BP CHEMICALS, INC.
MIXED WASTE POND CLOSURE PROJECT

FIELD CHANGE REQUEST FORM

Field Change Number: 024 Date: 12/17/96

Subject: Cell #1 Winterization

BATTEN STRIP ATTACHMENT DETAIL

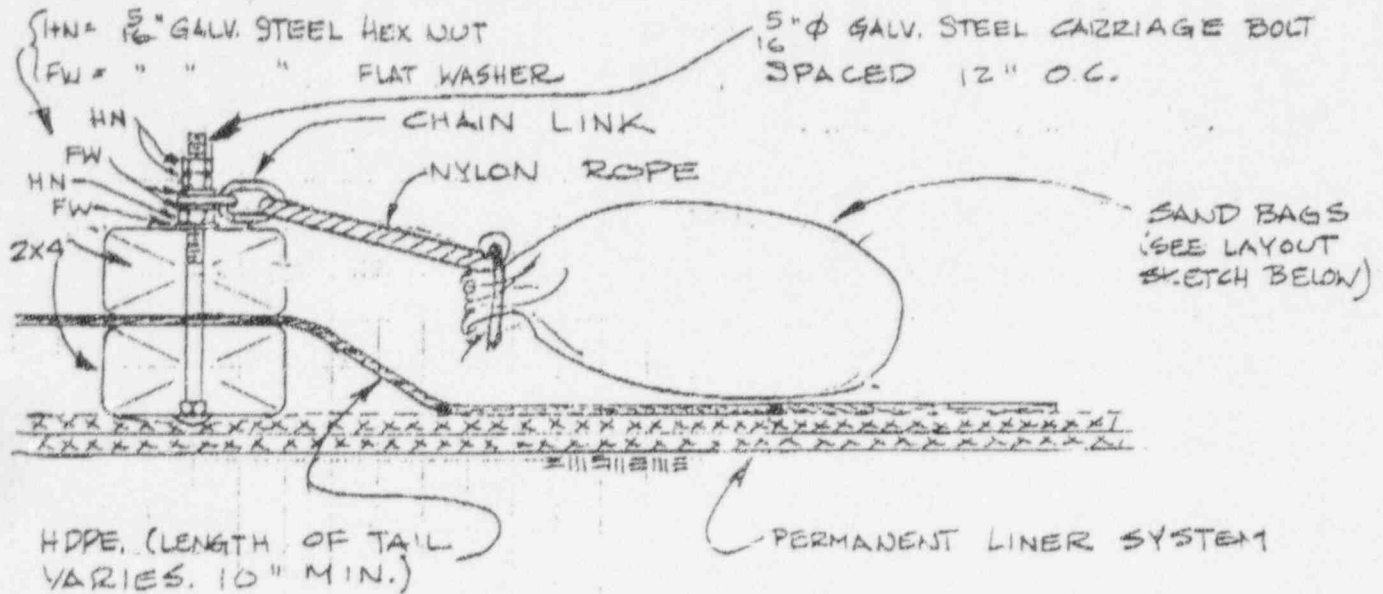
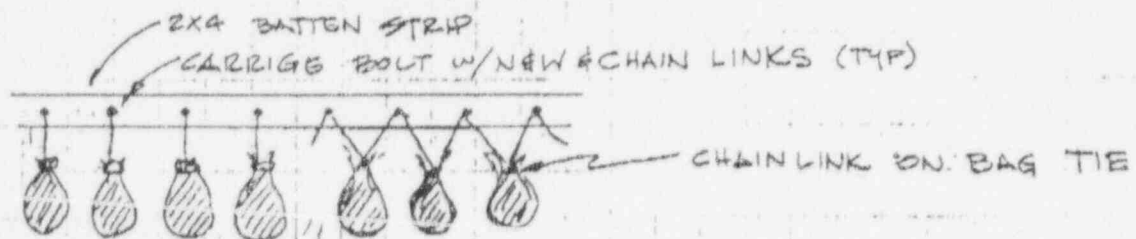
The sandbag ballasting should be attached to the HDPE with batten strips held together with carriage bolts. This will utilize friction rather than tearout to transfer the ballast load to the geomembrane and result in a much greater carrying capacity. It is important to tighten the bolts so that the round end of the carriage bolt is pulled into the wood. After the bolts are tightened, the lower surface of the batten strip should be carefully inspected and any splinters which might snag the woven geotextile should be removed by rough sanding. The sandbags should be attached to the batten strips with ropes tied to chain links which are attached to the carriage bolts with double hex nuts and washers. For the one foot attachment spacing shown, the sand bags should weigh at least 100 lbs. to resist flotation of the foam insulation with the sandbags submerged.

The HDPE is, based on GSE's published values, 22.5 ft wide. This should permit the installation with the roll direction horizontal over most of the cell. On the east side and a portion of the south and north sides, it will be necessary to have the roll direction vertical. For joints between panels, a six inch overlap will be sufficient. There should be a tail of at least 10 inches extending beyond the batten strip. The tail can be much longer, however, and the sandbags can be placed on the tail.

ALTERNATE 1 ALTERNATE 2 SAND BAG LAYOUT

CONSTRUCTION SEQUENCE

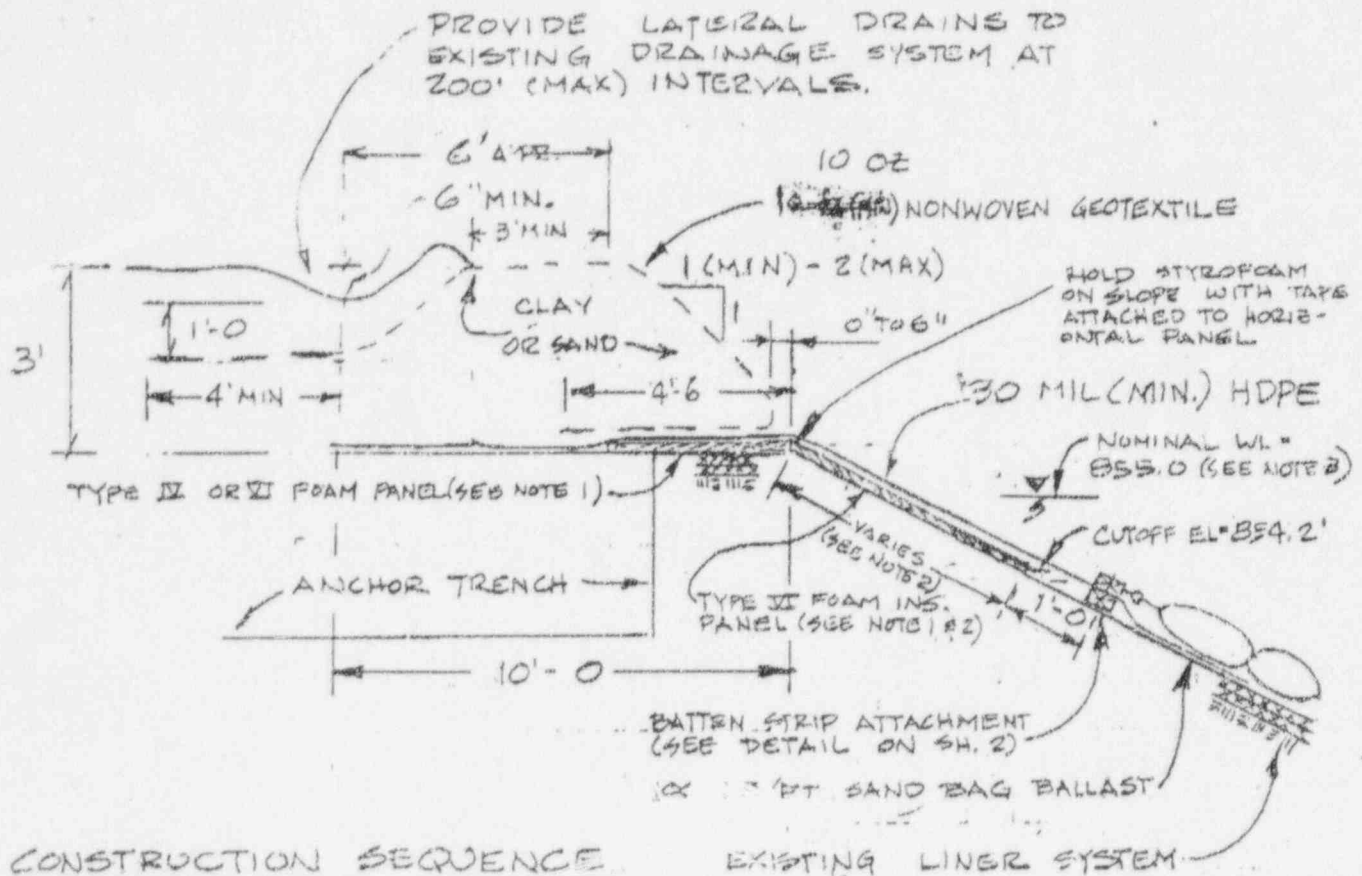
Enclosed is a sketch (2 sheets) with our recommendations for winterization of the V-1 cell. This sketch is based on discussions between representatives of BP Chemicals, Severson and Dames & Moore and is based on filling the ponds with water to a nominal elevation of 855.0, which will provide one foot of freeboard at the lowest perimeter point of the cell.

To provide protection against freezing and ice thrust, a layer of foam insulation, two inches thick is placed around the cell perimeter. The length of the foam insulation below the perimeter of the cell varies between four and thirteen feet as a function of the top of slope elevation. The additional length can be provided by installing the panels with the 8 ft dimension vertically and attaching additional pieces with tape. If this is done, it is important to cut the foam insulation panels so that the bottom of the panel is at elevation 854.2. This will keep the buoyant force, which must be resisted by the sandbags to a minimum.

1. PLACE FOAM INSULATION PANELS. HOLD IN PLACE W/ SANBAGS & TAPE.
2. PLACE 30 MIL. HDPE AND COVER WITH SAND OR CLAY EXCEPT FOR AREA 5' BACK FROM TOP OF SLOPE
3. PLACE NONWOVEN GEOTEXTILE AND SAND AS SHOWN ON SKETCH. ROUTE DITCH TO EXISTING STORM DRAINAGE IN FIELD.
4. ATTACH BATTEN STRIP TO GEOMEMBRANE.
5. ATTACH SANBAGS TO BATTEN STRIPS, TENSION ROPES.
6. FILL POND WITH WATER TO SPECIFIED DEPTH (SEE NOTE 3)
